**LAKE MANITOBA AND LAKE
ST. MARTIN OUTLET CHANNELS
PROJECT
Environmental Impact Statement
May 2023 Project Description
Update**

**PROJECT DESCRIPTION
UPDATE**

**LAKE MANITOBA AND LAKE ST. MARTIN OUTLET CHANNELS PROJECT
ENVIRONMENTAL IMPACT STATEMENT
MAY 2023 PROJECT DESCRIPTION UPDATE**

Figure 3C-20 LSMOC Typical Drop Structure

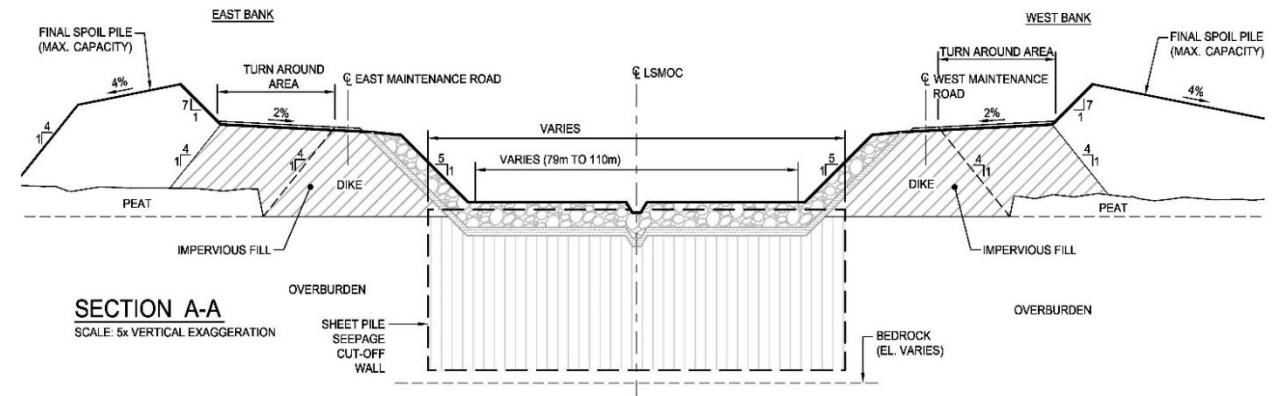
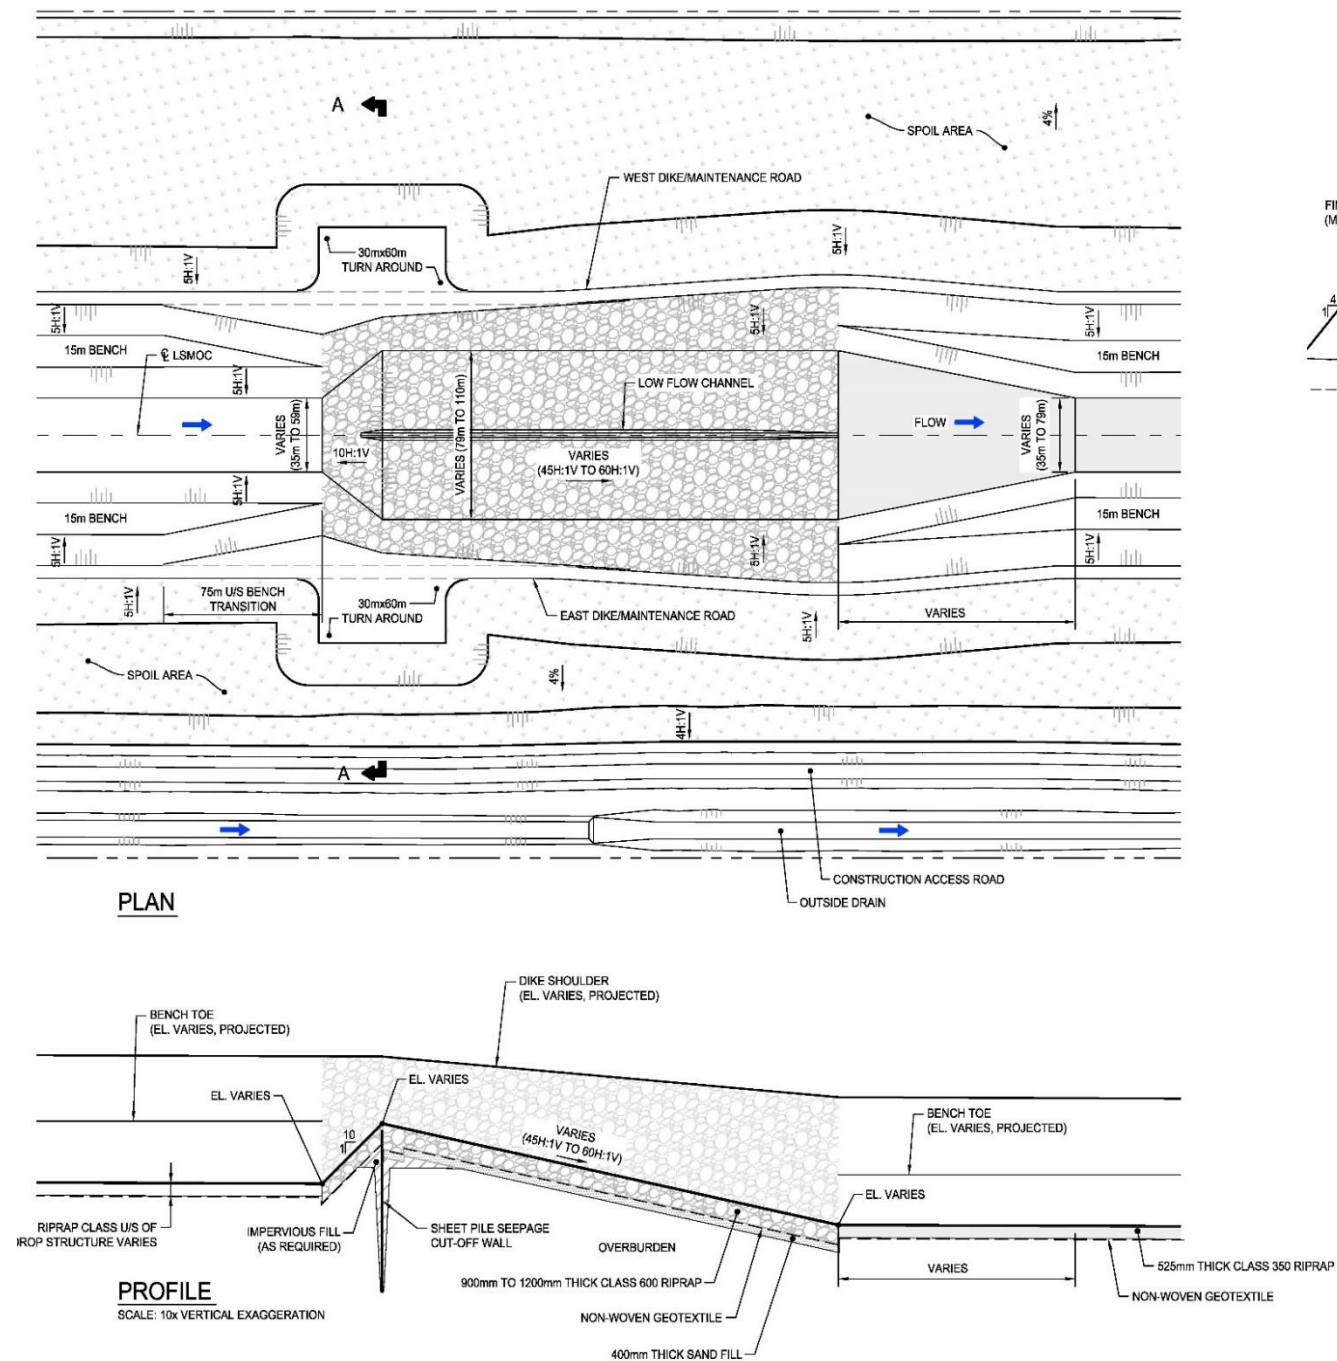
The LSMOC will require drop structures to manage flow velocities in areas of steep sloping terrain. A typical plan and profile of a representative drop structure is shown in Appendix 3C, Figure 3C-20. The current design and refinements from the March 2020 Project EIS are summarized below.

The locations of the drop structures have not changed substantially from what is shown in the March 2020 Project EIS, as shown in Appendix 3C, Figure 3C-3. The current design still includes eight drop structures. The design of the drop structures remains consistent with what was presented in the March 2020 Project EIS. The structures will be constructed of rockfill with a cutoff wall at the crest. The approximate weir and drop heights of the structures have not changed substantially. The slopes of the rock ramps were flattened to reduce the risk of erosion at the Design Flow. Another modification that was made is that the low-flow trapezoidal chute that extends down the length of the rock ramp will be grouted. This will provide a more uniform flow depth in the chute and will reduce the potential for fish stranding in voids between the rocks.

The height of the drop structure weirs range between 2.5 m (8.2 ft) and 3.7 m (12.1 ft). The overflow crest widths range from 80 m (262.5 ft) to 125 m (410.1 ft). Cutoff walls are included at the crests to prevent flow through the structures when the LSMOC is not in operation. Sheet pile will be used as the cutoff walls for all structures with the exception of the fourth drop structure. At this structure, a concrete cutoff wall will be used due to the shallow depth to bedrock and inability to drive sheet pile.

Figure 3C-22 LSMOC Permanent Drainage Plan

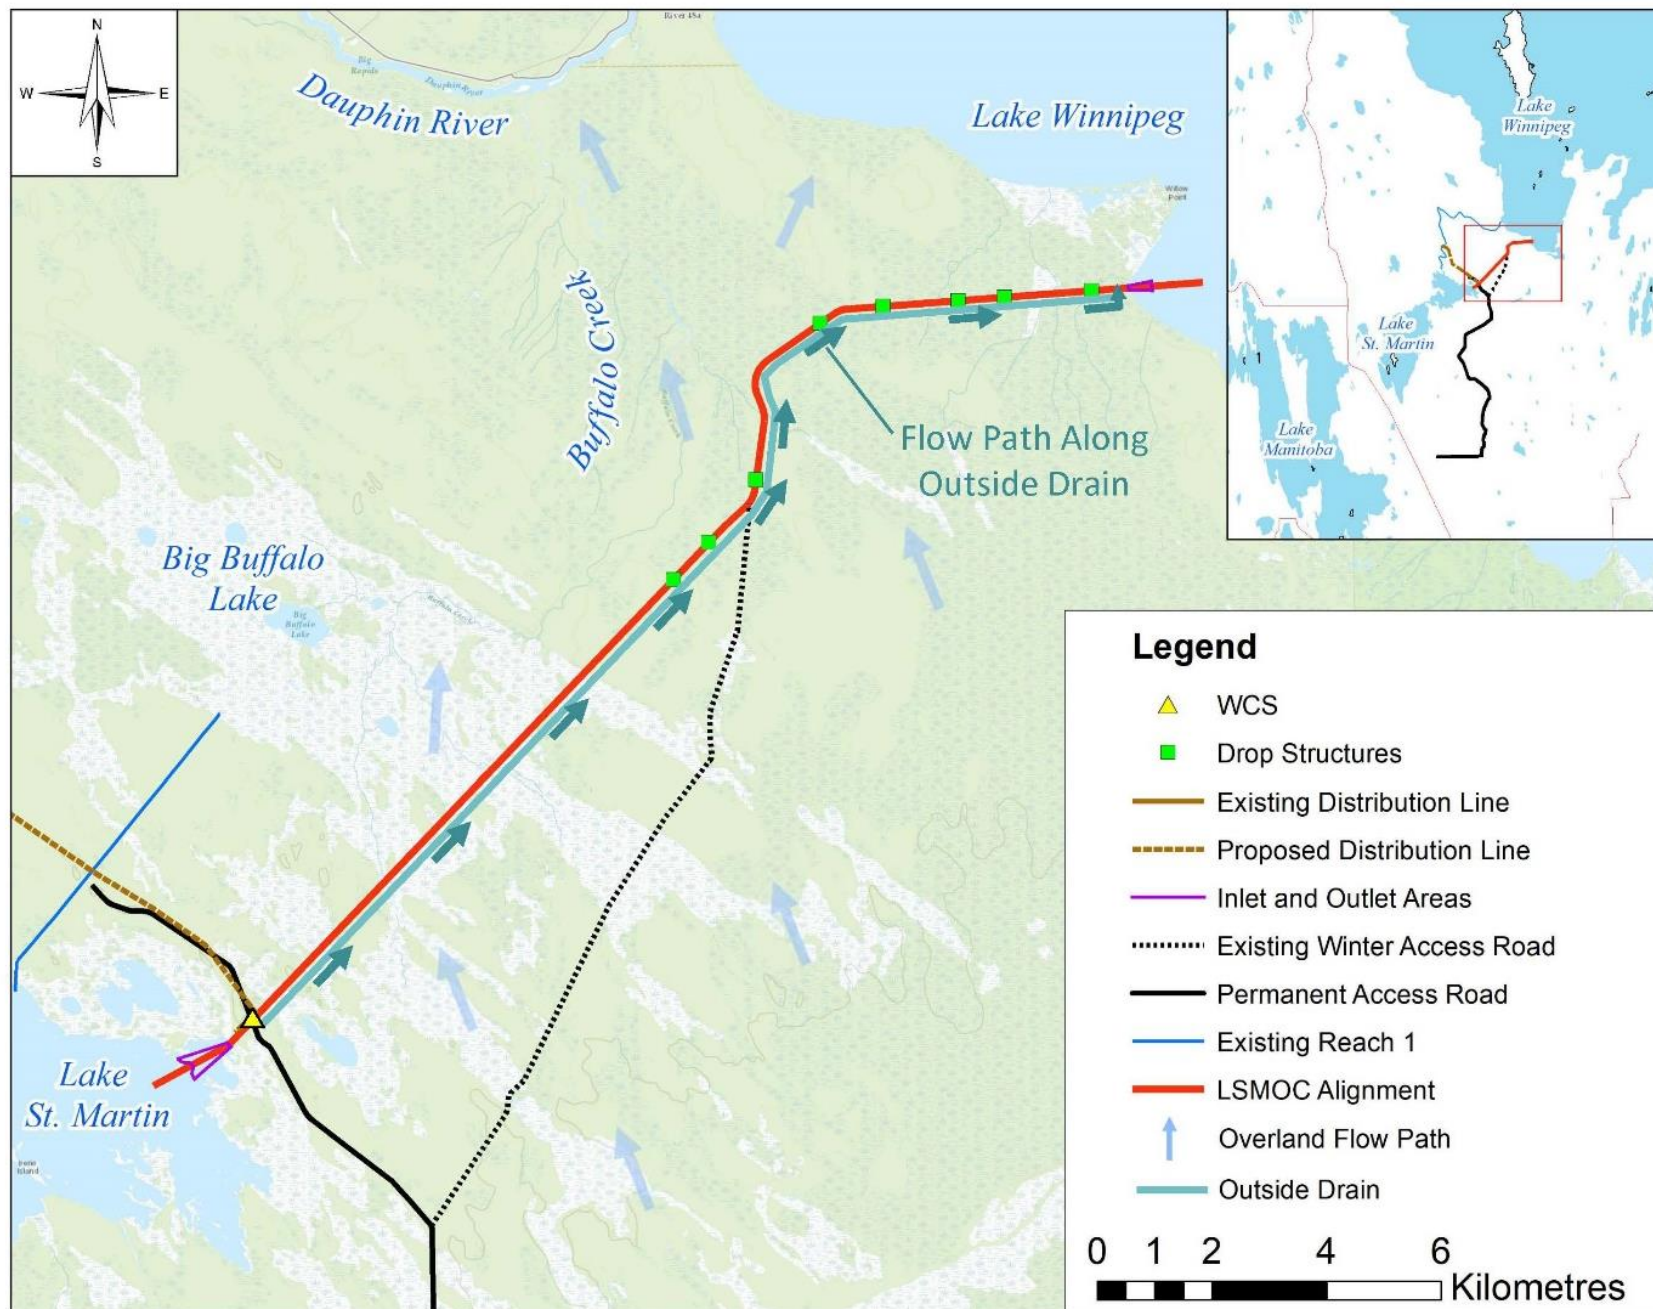
Appendix 3C, Figure 3C-22 shows the permanent drainage plan for the LSMOC. For upgradient flows, a drainage ditch, or outside drain, will be constructed on the east side of the channel to collect existing drainage flowing from the east. On the west (downgradient) side of the LSMOC, surface water naturally flows away from the channel toward the peatlands and Buffalo Creek. Therefore, no outside drain is

Figure 3C-23 Typical Cross-Section of LSMOC Outside Drain

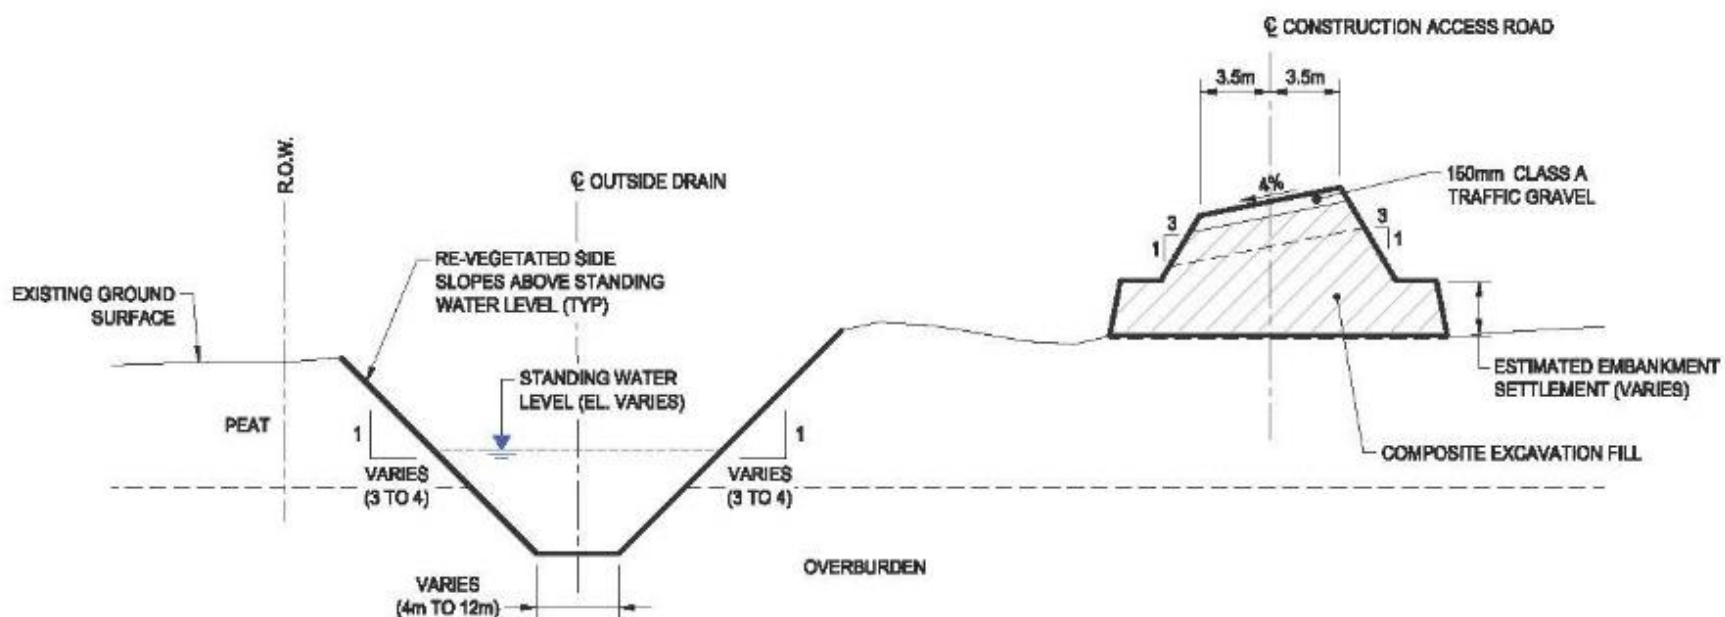
The outside drain is comprised of a trapezoidal excavated channel, as shown in Appendix 3C, Figure 3C-23. The drain invert was selected to reduce excavation volumes while also reducing inundated areas at the 1 in 10-year design runoff event. The drain invert intersects both peat and mineral soil along its length. In areas where the drain runs through peat, the cross-section will have side slopes of 3H:1V. In areas where the drain runs through mineral soil, the side slopes will be 4H:1V. The base width of the drain varies from 4 m (13.1 ft) at the upstream end to 12 m (39.4 ft) at the downstream end, to account for the accumulation of flow in the downstream direction. The typical invert slope of the drain is 0.06% with the exception of two reaches that have slopes of 0.02% and 0.04% to better fit the natural topography.

Figure 3C-24 Rockfill Gradient Control Structures

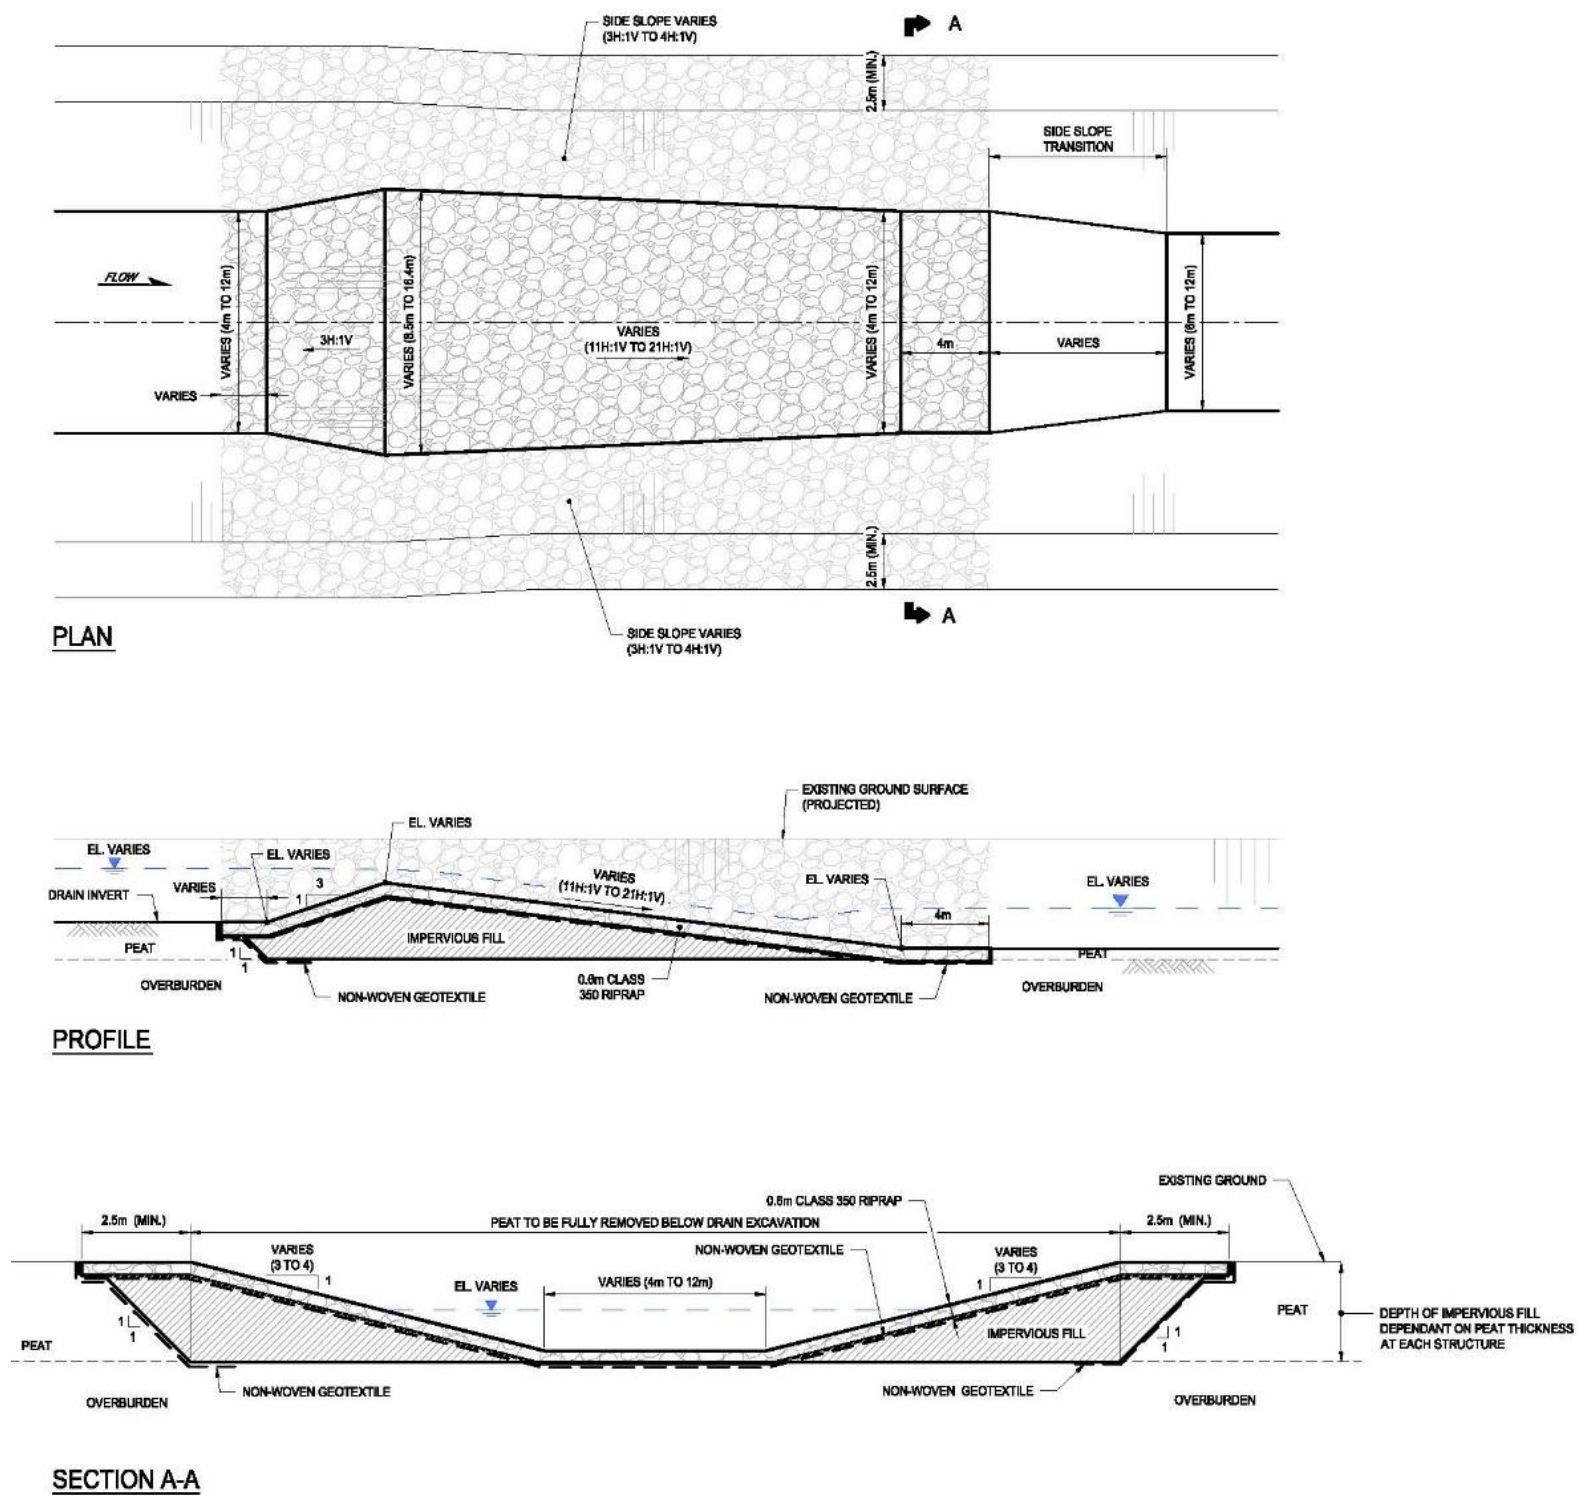
Fourteen rockfill gradient control structures (GCSs) will be constructed along the drain to limit water velocities and shear stresses to permissible levels and reduce the risk of erosion in the drain. As shown in Appendix 3C, Figure 3C-24, the GCSs will be rockfill structures with raised crests and steep chutes. The chutes will be protected with riprap to prevent erosion from the high velocities in the region where the water surface elevation is lowered over a short distance. The GCSs are designed to withstand flows up to the 1 in 25-year event with limited damage and flows up to the 1 in 200-year event without complete failure (i.e., washout of structures). The construction road that will be constructed adjacent to the outside drain during the site preparation contracts will be used to access the outside drain for future maintenance. Routine maintenance activities will likely be required and will mostly consist of regrading and/or replacing of riprap that has moved or settled from its original position. Placement of additional riprap on the edges of the structures or at locations where erosion has occurred may also be required to mitigate the development of alternate flow paths.
